SERVICE PROCEDURE

REFERENCE: FSA 202515

SUBJECT: Gen 2.0 Intercooler Pipe (Blue) Hardness Issue

FSA TYPE: Customer Notification

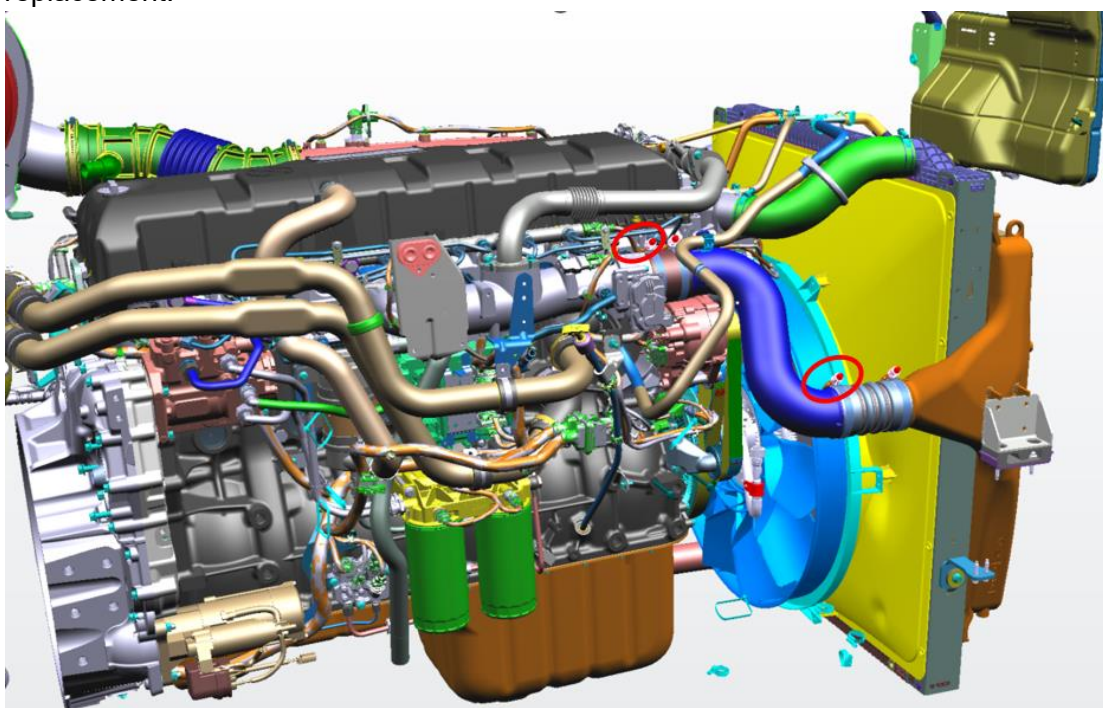
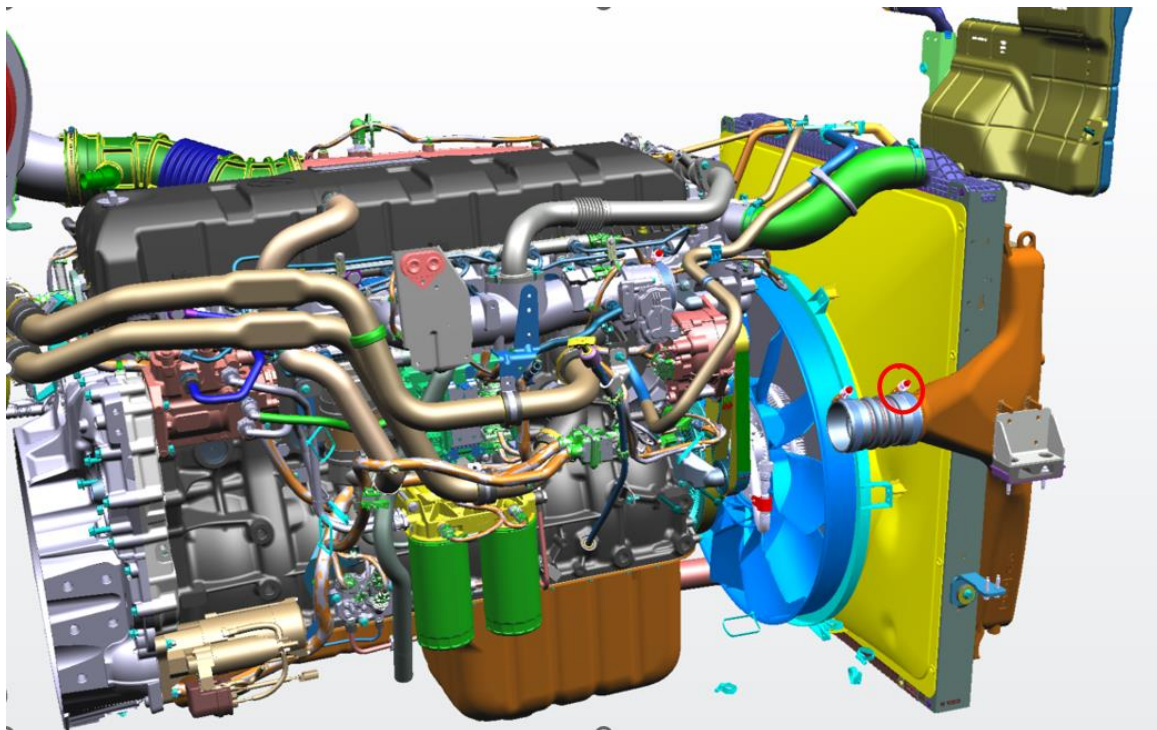
1. Lift the vehicle cabin to make the part visible.
2. Remove the two clamps marked below. Keep the removed SC46 6F073 A/B part aside for reinstallation after replacement.

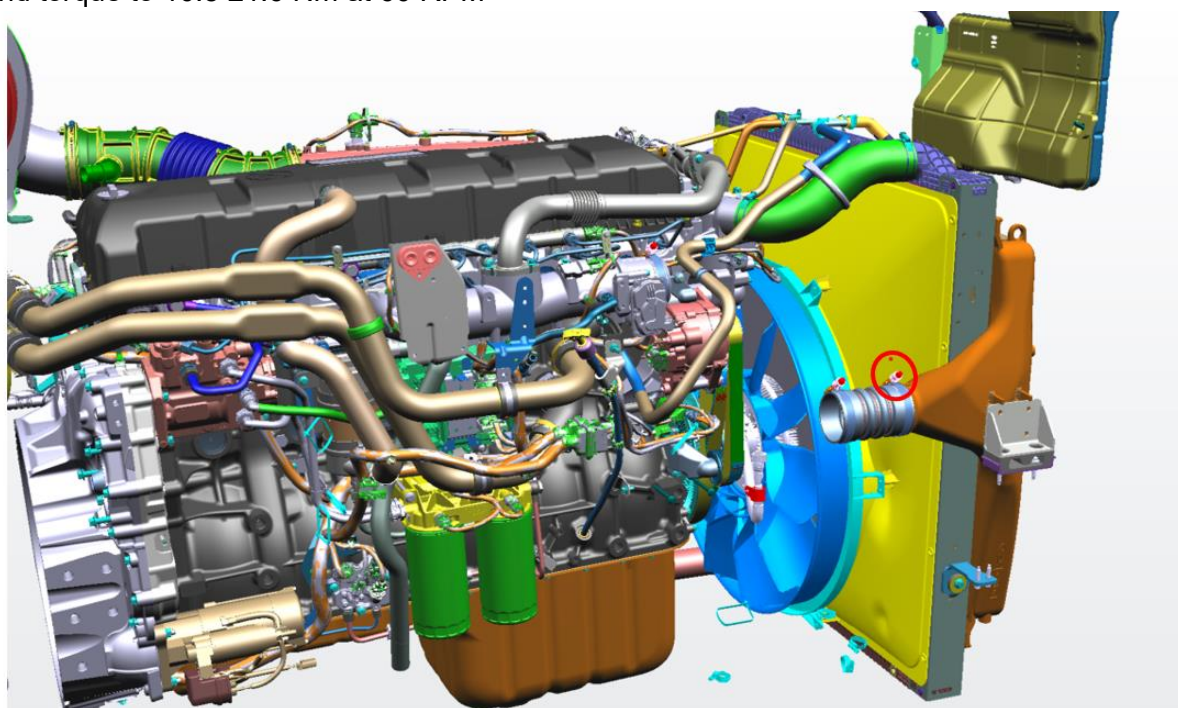
3. Remove the clamp connecting the SC46 6K770 CA part to the intercooler outlet part as marked below.

4. After replacing the SC46 6K770 CA part with a new one, first tighten the clamp in the indicated direction and torque:
 - Torque: First torque to 7 Nm at 350 RPM
 - Second torque to 10.5 ± 1.6 Nm at 60 RPM

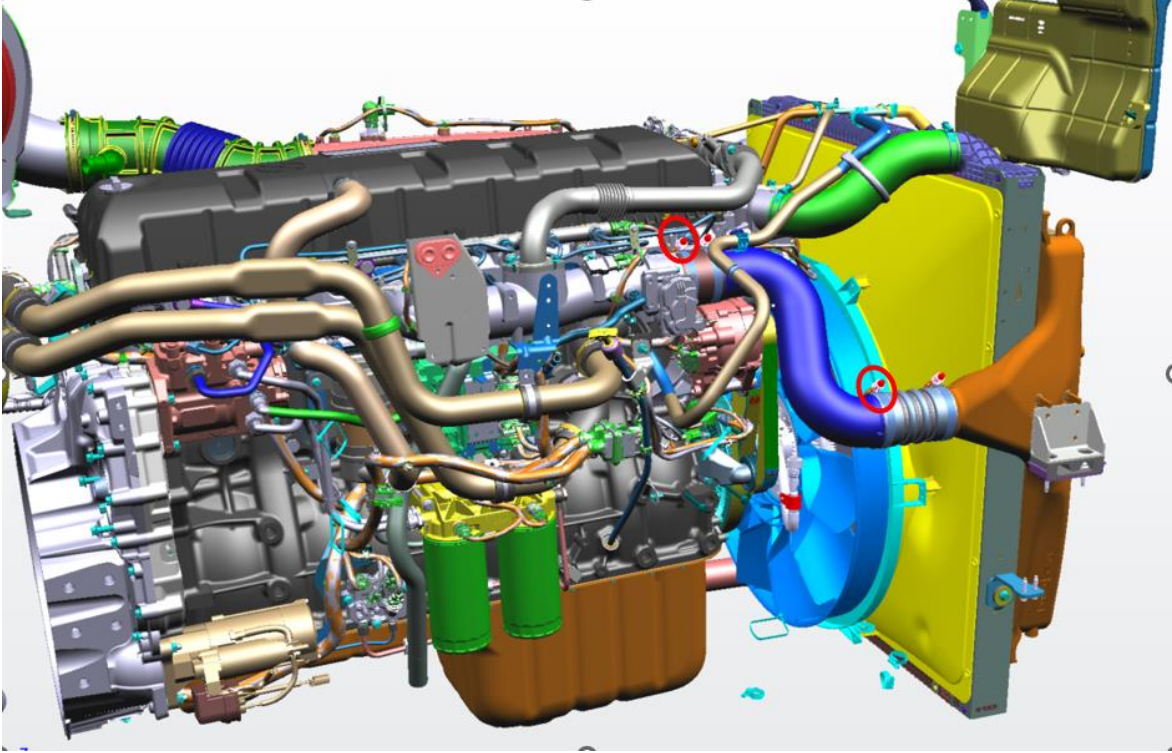
5. Reinstall the previously removed SC46 6F073 A/B part properly and tighten the marked clamps in the indicated direction and torque:
 - Torque: First torque to 7 Nm at 350 RPM
 - Second torque to 10.5 ± 1.6 Nm at 60 RPM

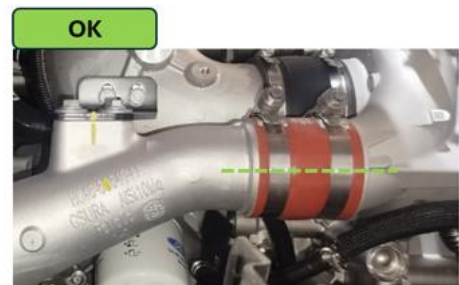
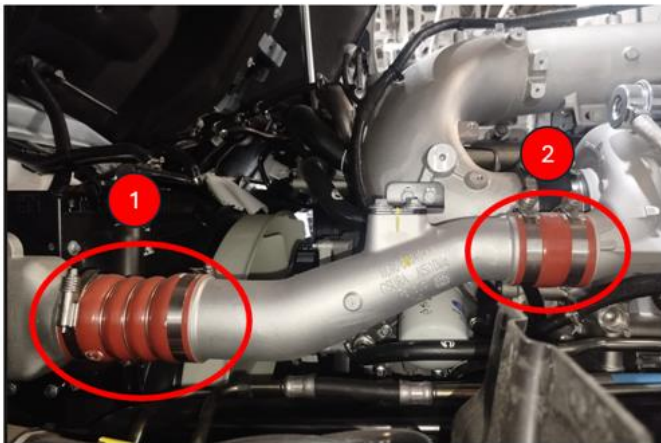
6. The inspection will be carried out on pipes 1 and 2 based on the OK/NOK images. If there is any axial misalignment in these pipes, similar to the NOK image, they will need to be repaired.

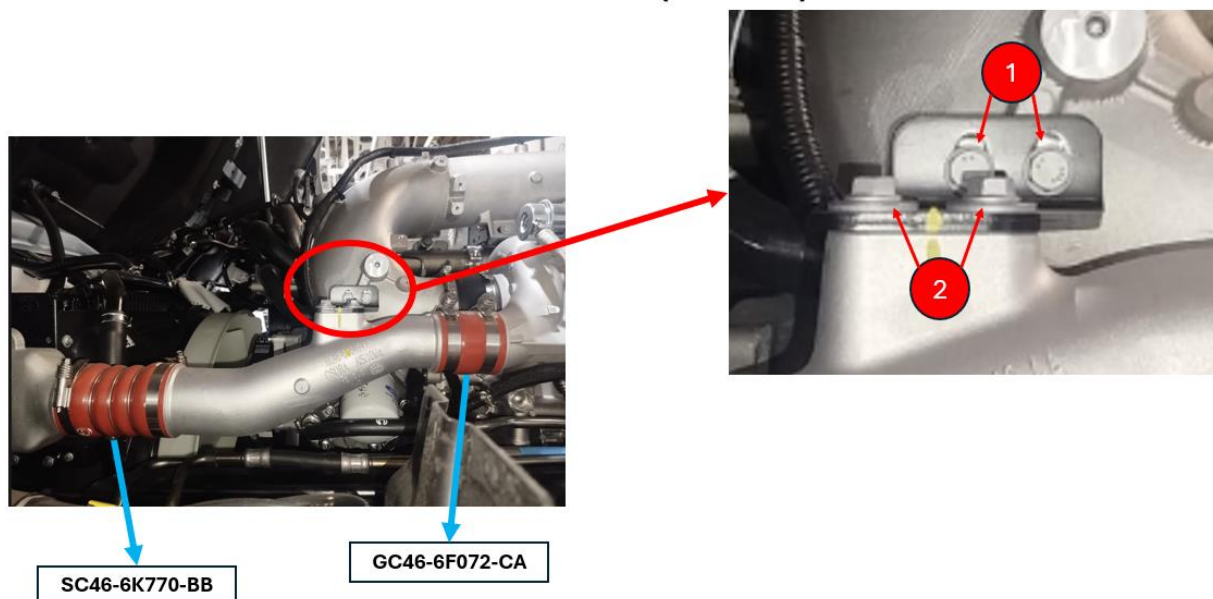
- Loosen the 4 bolts securing the bracket.
- Ensure that the pipes self-align and achieve concentricity.
- Finally, torque the bracket bolts (torque bolt 1 first, followed by bolt 2).

Initial Torque: 7 Nm

Final Torque: 10.5 ± 1.6 Nm

Torque: 25 ± 3.8 Nm
